ORIGINATION FORM

Proposed Revisions to a Standard Plans Index

Index Number: 455-440
Sheet Number (s): 1 of 4
Index Title: Precast Concrete Sheet Pile Wall (CFRP/GFRP & HSSS/GFRP) +

PRECAST CONCRETE SHEET PILE WALL
 (CFRP/GFRP & HSSS/GFRP)

SECTION THRU BULKHEAD
 (Showing Plastic Filter Fabric)

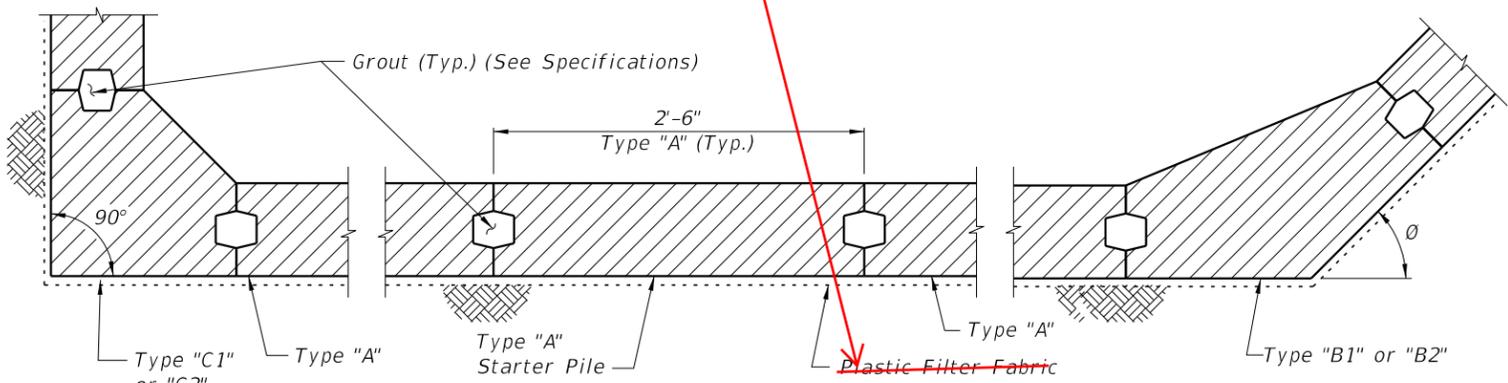
~~PLASTIC FILTER FABRIC:~~
~~The plastic filter fabric shall extend to the bottom of the "X" dimension.~~

Plastic Filter Fabric
 (Continuous)

Bottom of Dim. X
 and Filter Fabric

CHANGED:
 Provide and install Type D-2 or D-3 geotextile in accordance with Specification 514. Extend the geotextile to the bottom of the "X" dimension.

CHANGE: Geotextile

SECTION THRU BULKHEAD
 (Showing Geotextile)

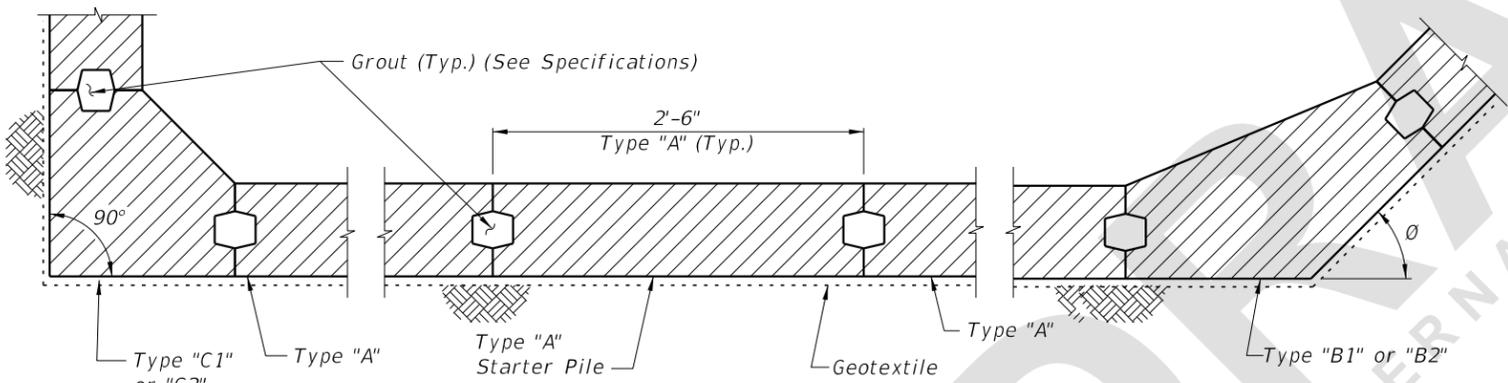
Sheet 1: Changed the "PLASTIC FILTER FRABRIC" Note in the SHEET PILE DESIGN CRITERIA AND NOTES to "GEOTEXTILE: Provide and install Type D-2 or D-3 geotextile in accordance with Specifications 514. Extend the geotextile to the bottom of the "X" dimension."; Changed all references of "Filter Fabric" or "Plastic Filter Fabric" to "Geotextile".

GEOTEXTILE:
 Provide and install Type D-2 or D-3 geotextile in accordance with Specification 514. Extend the geotextile to the bottom of the "X" dimension.
